**Medway DPW Water Quality Treatment  
Facility Site Plan – 19 Populatic Street**

**SUBJECT: Populatic Water Treatment Plant – Major Site Plan Review  
19 Populatic Street, Medway, Massachusetts**

Wright-Pierce has received Tetra Tech's comments on the Major Site Plan Review submission for the Populatic Water Treatment Plant project. We have prepared the following letter and attachments in response to these comments.

DRAWING  
C-6

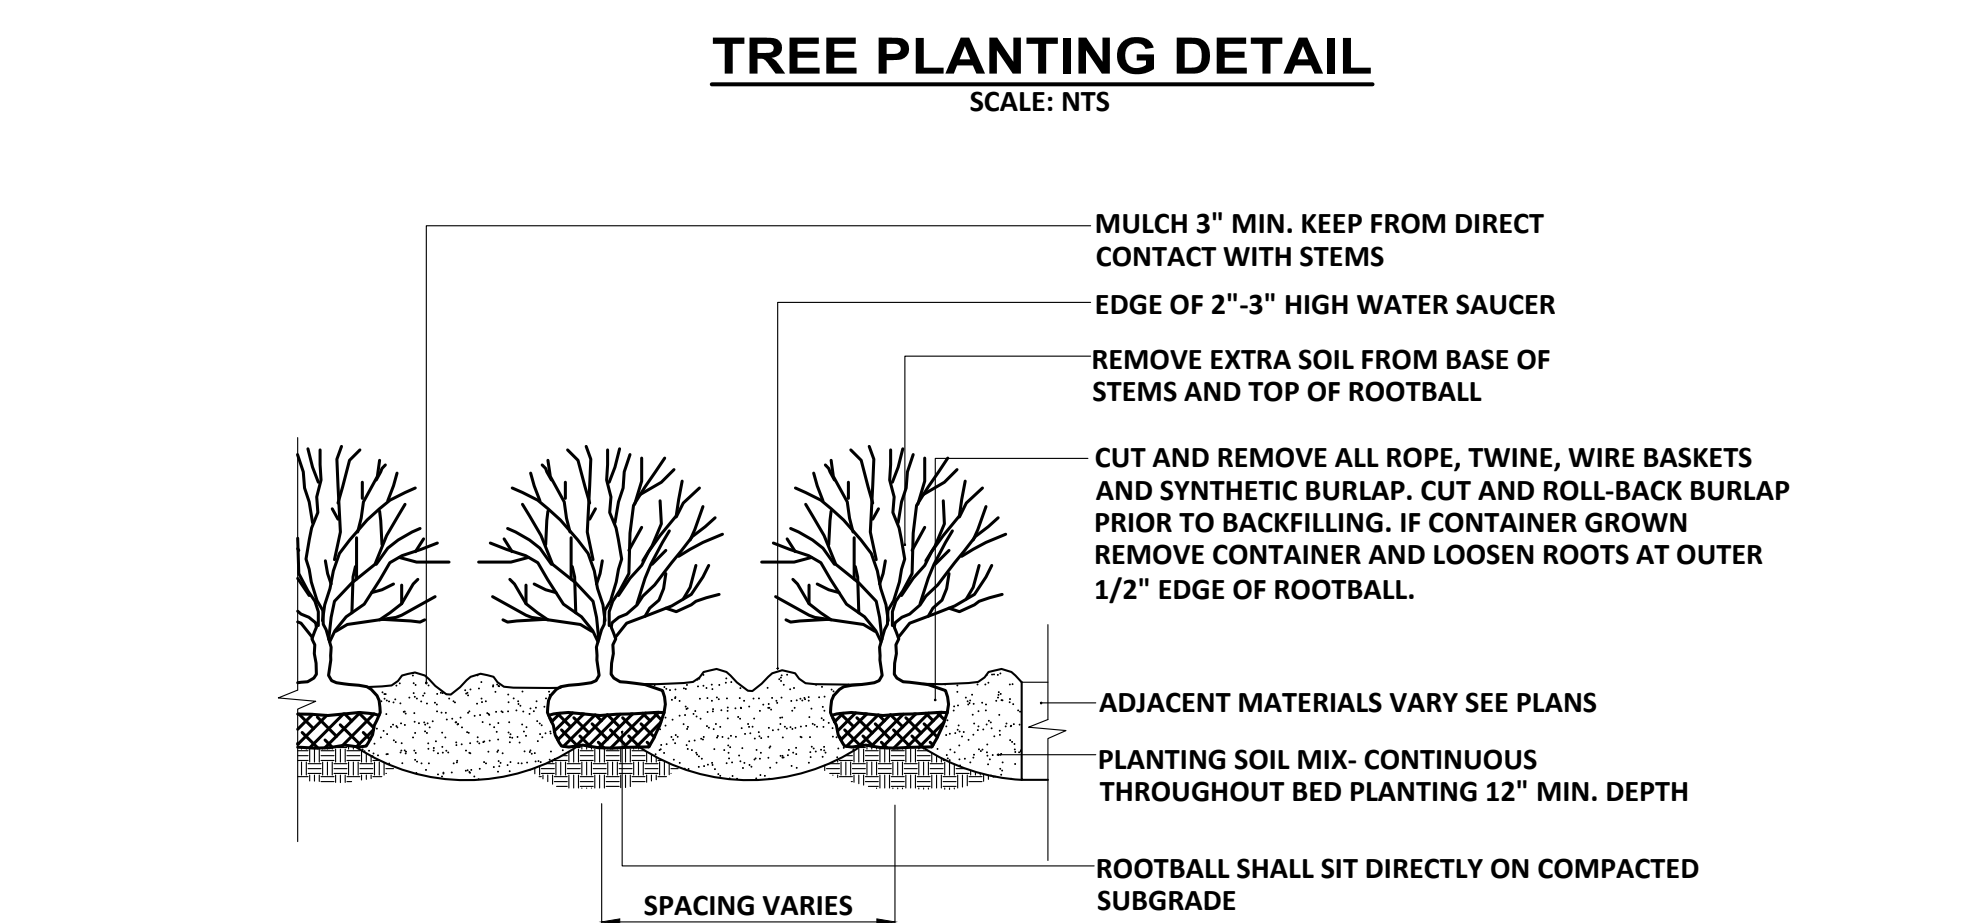
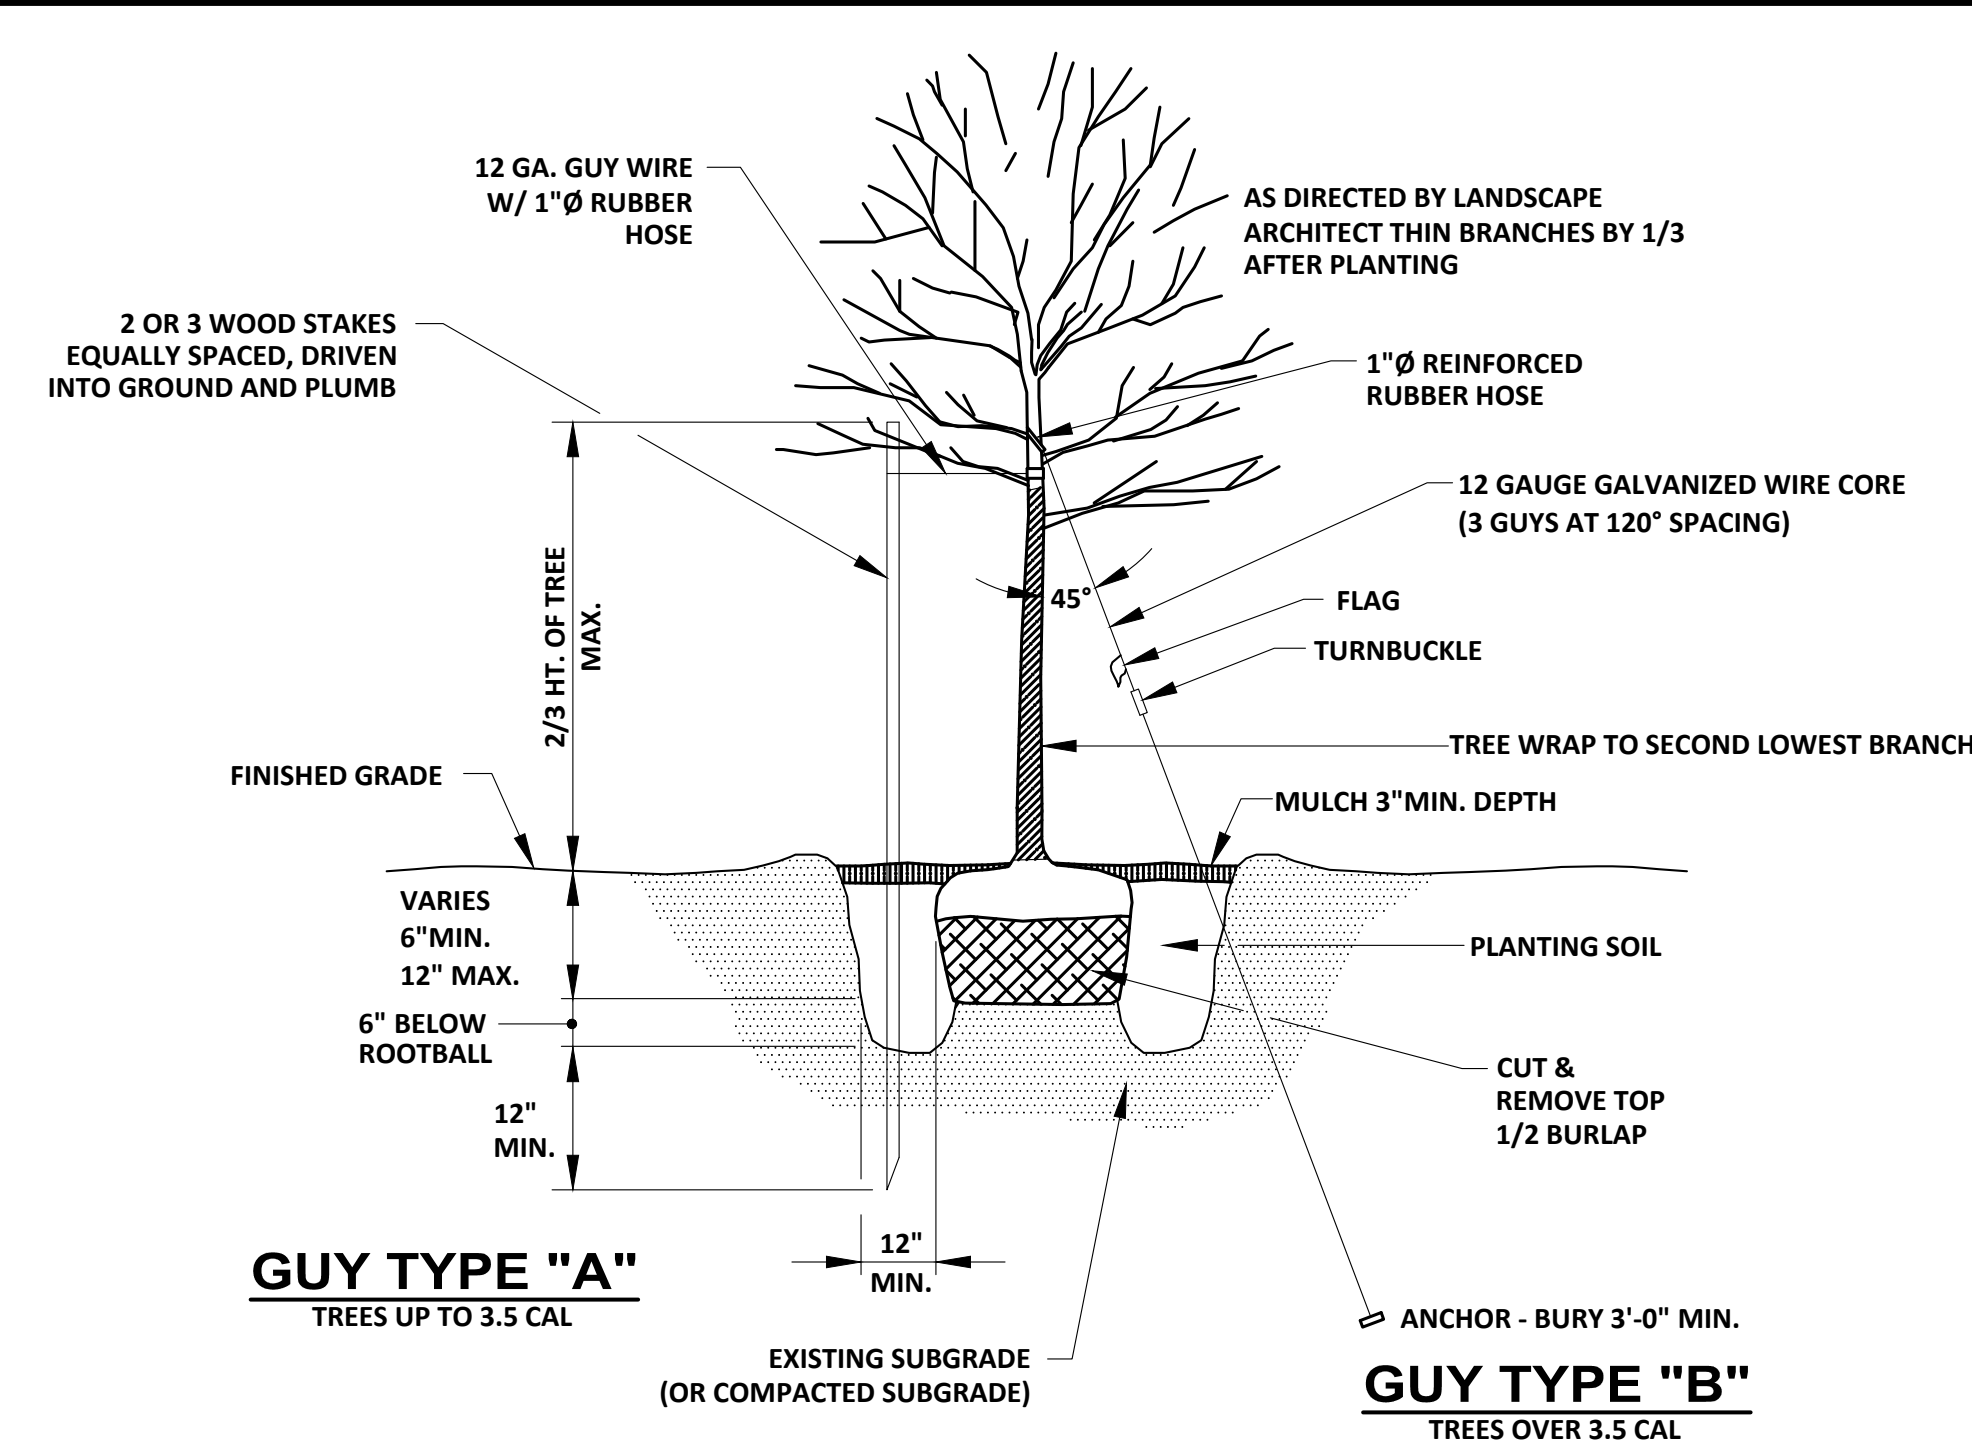
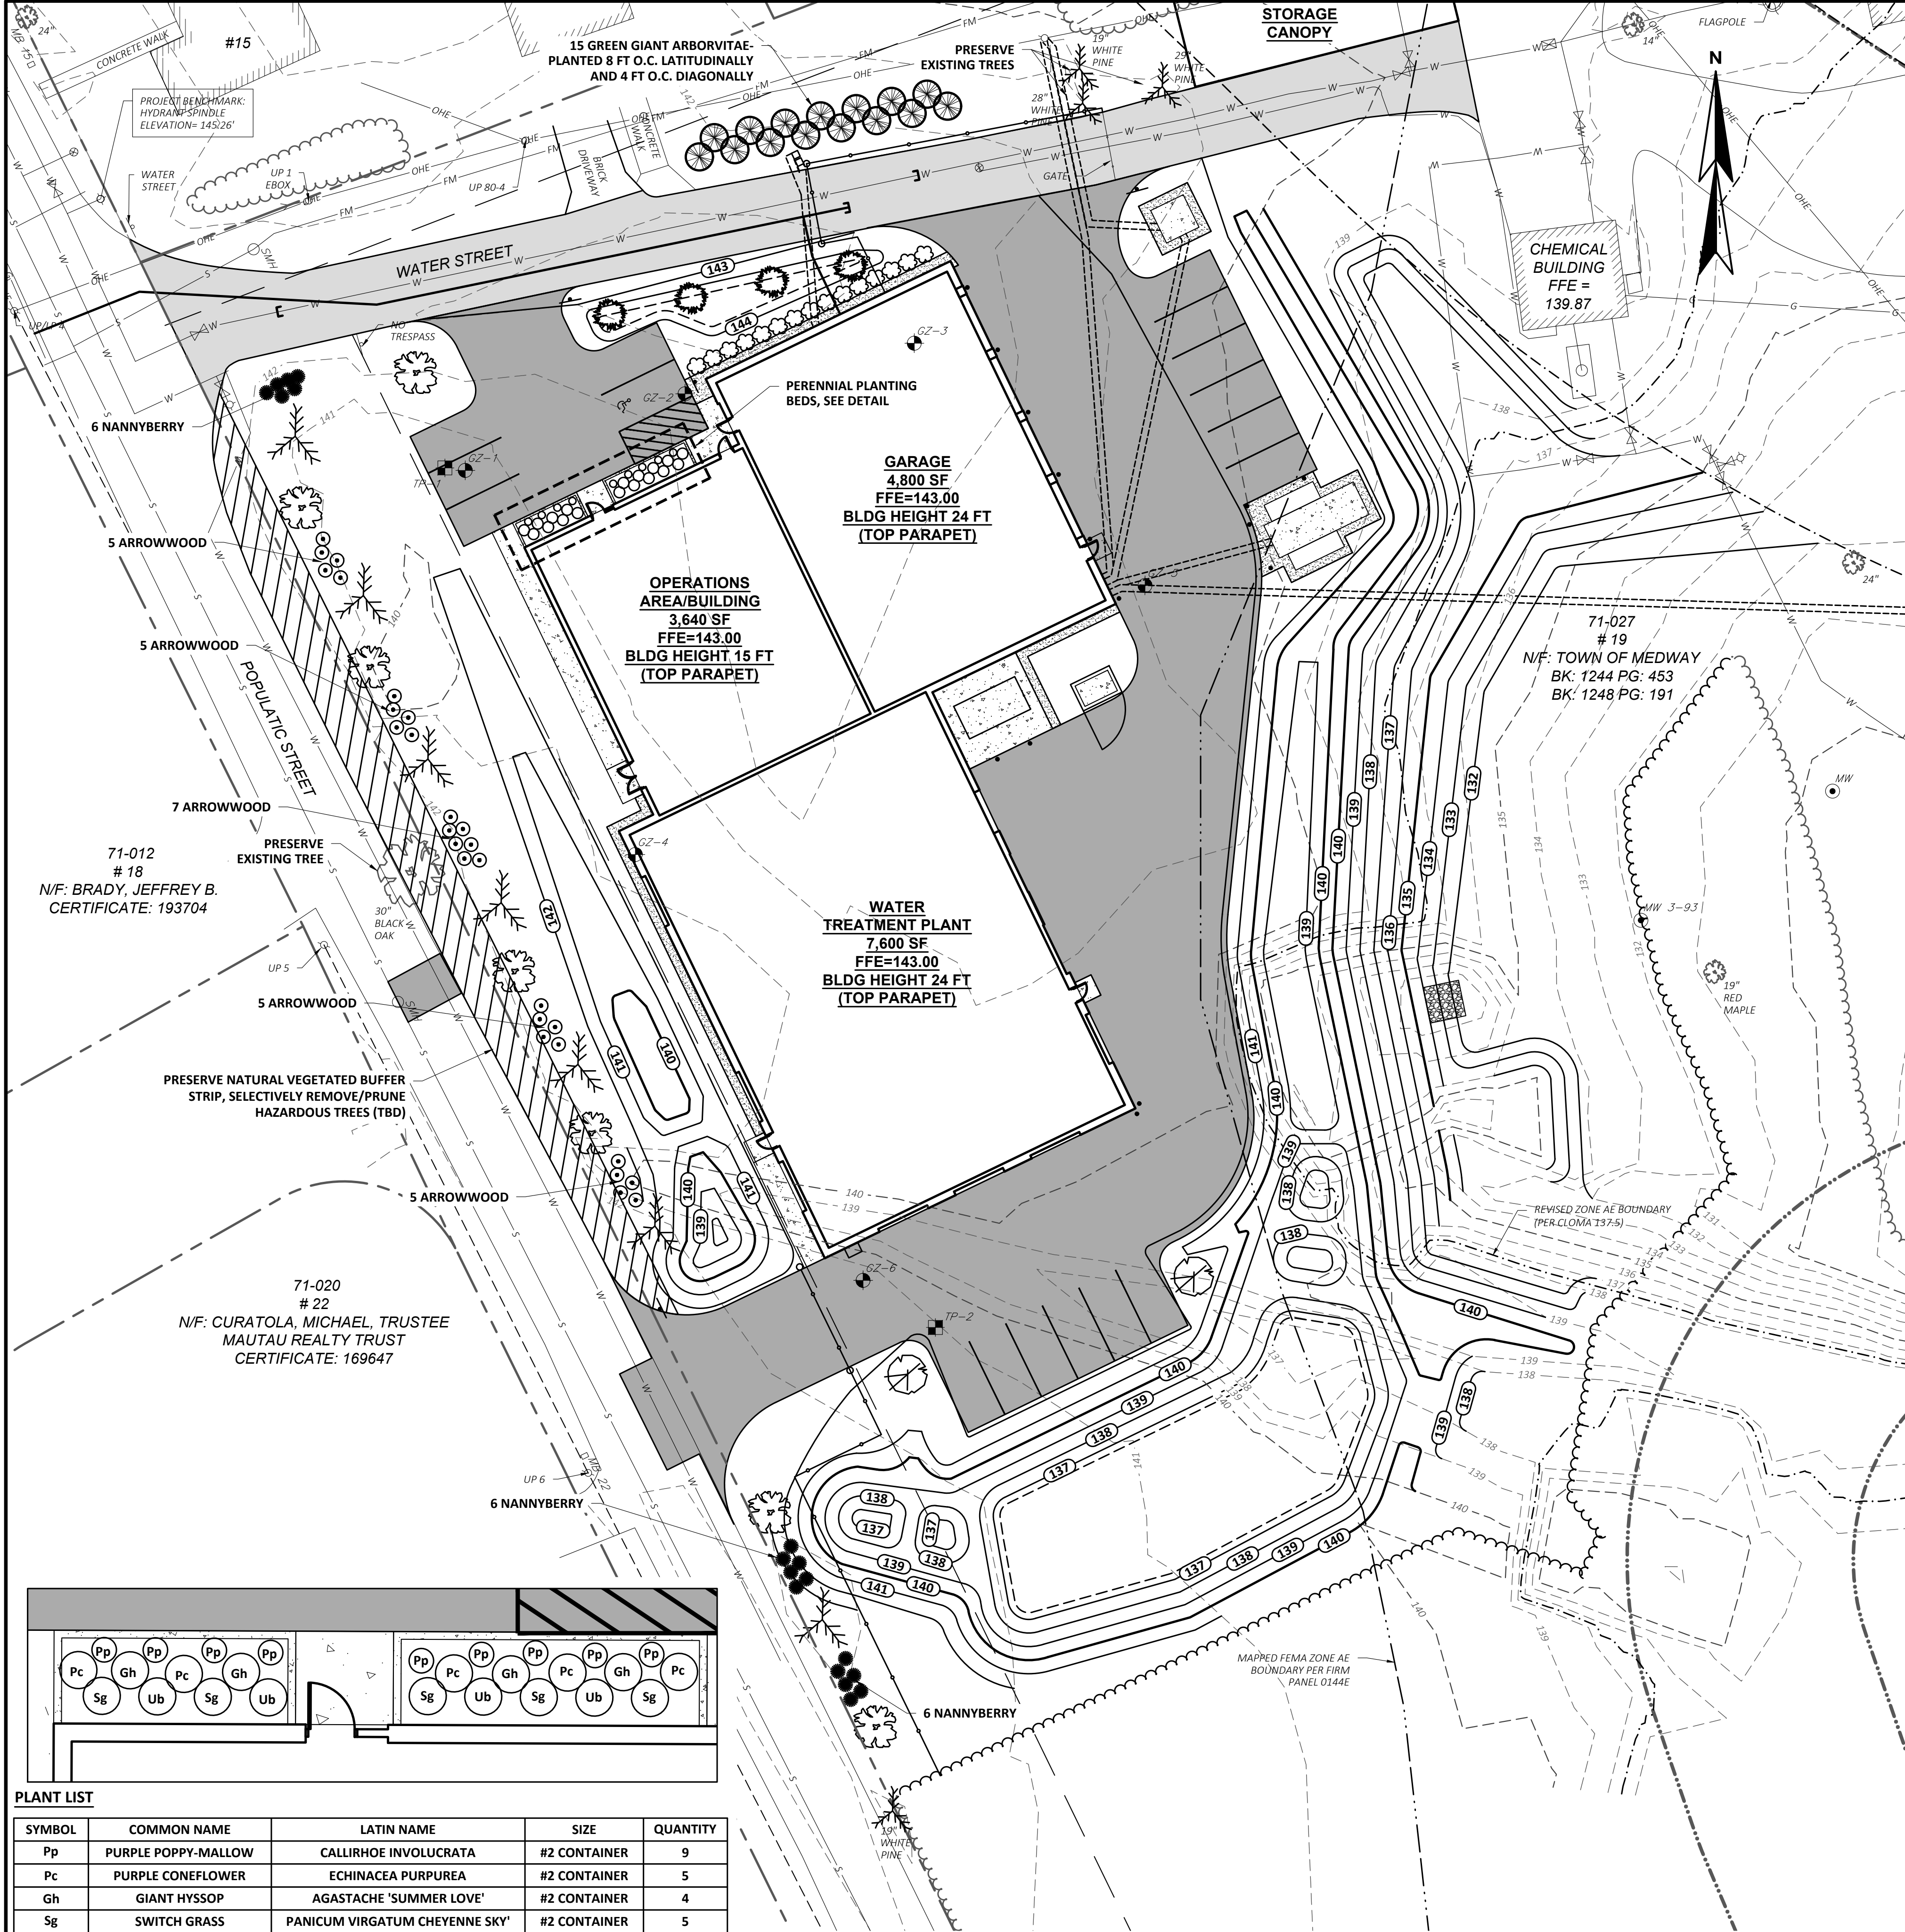
24. Minimal screening of the Project has been provided along the northern side of the project, particularly between the project site and the abutters to the north. We recommend the Applicant provide screening along the north side of Water Street. (Ch. 200 §207-19.D)

***Response: The Landscaping Plan (C-6 has been updated in the revised drawing set to include additional screening on the north side of Water Street. Refer to Attachment C.***
